iVI		anaa Daa	Incot	Earm	Varia	anco Doguoci	
1		vr vari	ance Req	uest	ruim	varia	ance Request No.:	A-9
	untain Valley		ח	ate Ar	proval R	equested	by Contractor:

Mountain Valley Pipeline Project Variance A-9 April 16, 2018

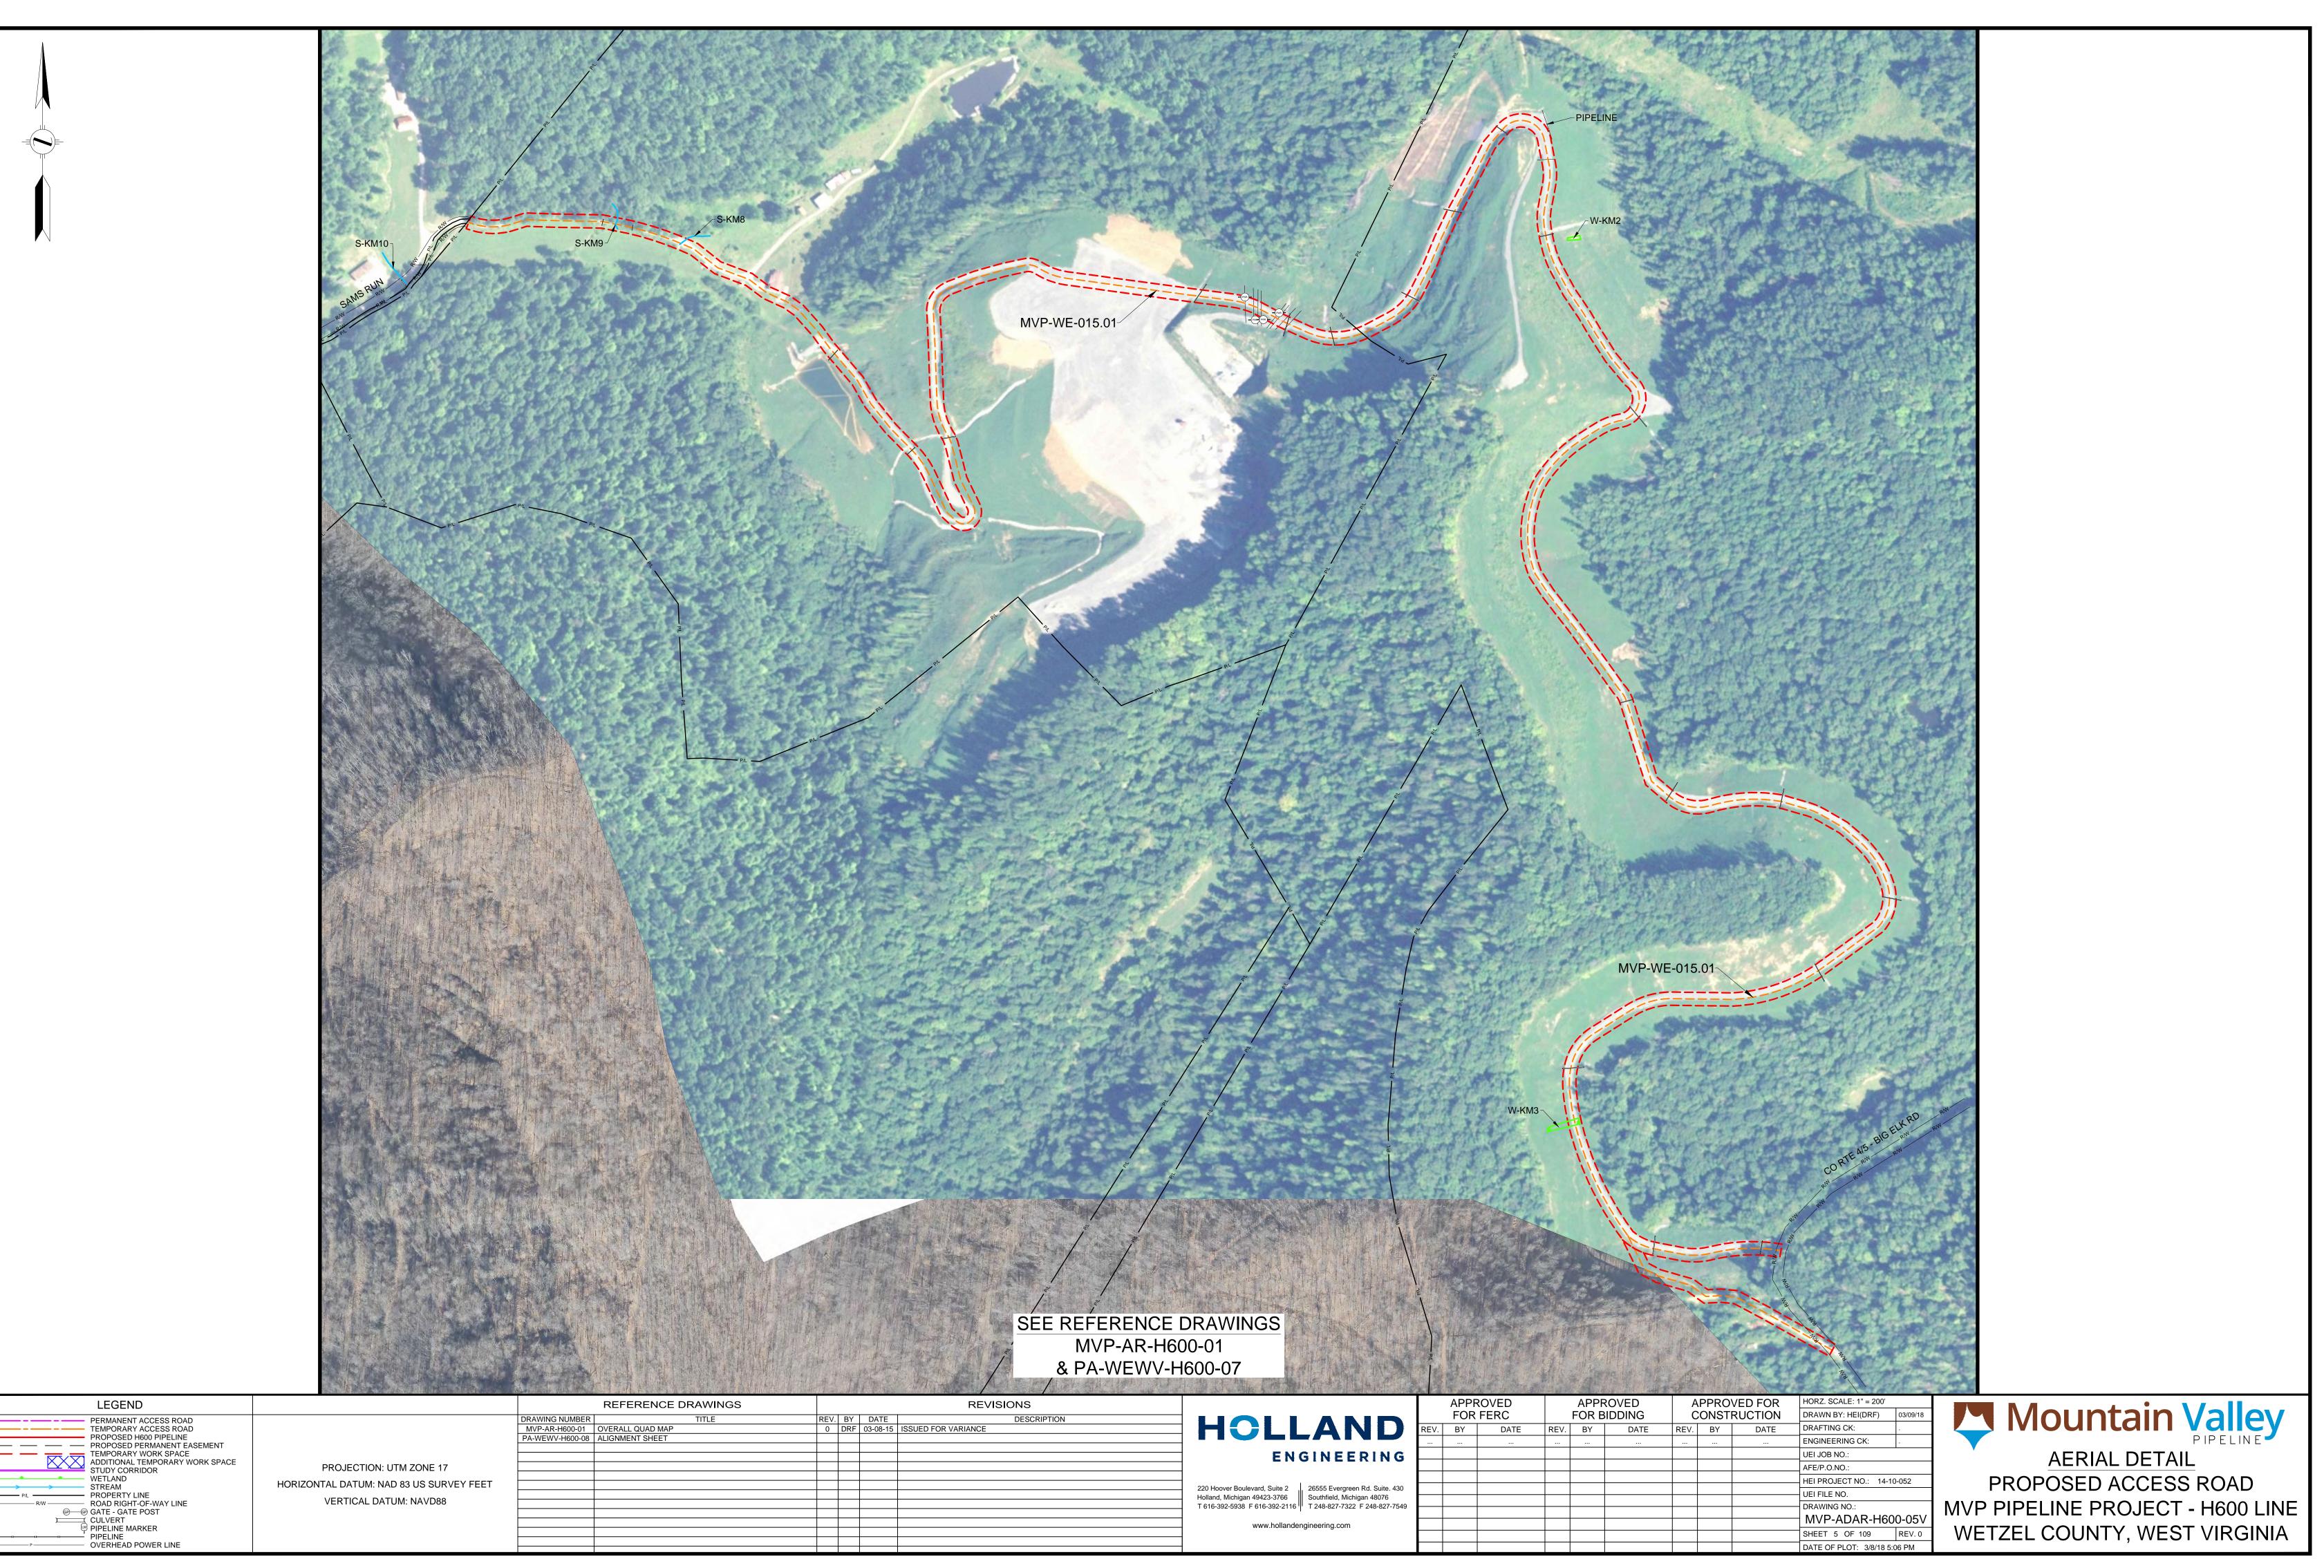
-			Acreage of	tree				
Tree Clearing Required:	No		Acreage of clearing		0.	.00		
Tree Clearing Required:			clearing		0.	.00		
Tree Clearing Required: Variance Level:	Level 1		clearing	:				
Tree Clearing Required: Variance Level: Variance From:	☐ Level 1	Level 2	clearing	:	<i>O</i> .] Specificati		awing 🗌 Miti	gation Measure
Tree Clearing Required: Variance Level: Variance From:	Level 1		clearing	:		on 🗌 Dr	awing 🗌 Miti	gation Measure
Tree Clearing Required: Variance Level: Variance From:	Level 1 Permit Plan Line List	Procedur	clearing] Specificati Other: Des	ion 🗌 Dr scribe:		-
Tree Clearing Required: Variance Level: Variance From: [Detailed Description of	Level 1 Permit Plan Line List Variance:	Procedur	clearing	: es [] Specificati Other: Des] No	on Dr scribe: Photo	os?	Yes 🔽 No
Tree Clearing Required: Variance Level: Variance From:	Level 1 Permit Plan Line List Variance: Variance: rary access road N o be from the wes t. This variance in for their operation g the road are own cause once it exits MP 7.9 off the pul ce LOD. Streams ossings will not be acts. Wetland W-H	Procedur Attachmer Attachmer VVP-WE-01 t using the p creases the s prior to M ed by Murra s parcel WV blic road. N S-KM8 & S- modified ar KM3 has be	Clearing ✓ Level 3 es □ EPPM Atts? ✓ Yo 5.01 which is no bublic road but of LOD by 10.05 WP being there ay Coal and will -WE-5970 it en- lo cultural resou- KM9 were iden ad will incur no iden delineated in	es C ecessa due to acres y not be ters the irces o tified y mpact	Specificati Other: Des No ary for pro an tunnel with no tre y will main e impacte e public R or rare, thr within the s. Wetlan he LOD b	on Dr scribe: Photo Dject access I preventing ee clearing ntain the ro d by MVP's ROW for Sa reatened o LOD. Both d W-KM2 I but will be s	s. Originally, ac g access for eq being present. ad and require s work. The acc ams Run. Const r endangered s streams cross has been deline panned with a t	Yes No ccess for this portio uipment access is Murray Coal has no changes at this cess road does not truction will simply pecies were the access road in tated but is outside timber mat bridge

Variance Justification:

Necessary for access. Resources have been avoided to the extent practicable. Per approved Project plans, BMPs will be installed to minimize potential impacts to Environmentally Sensitive Areas within/abutting the area.
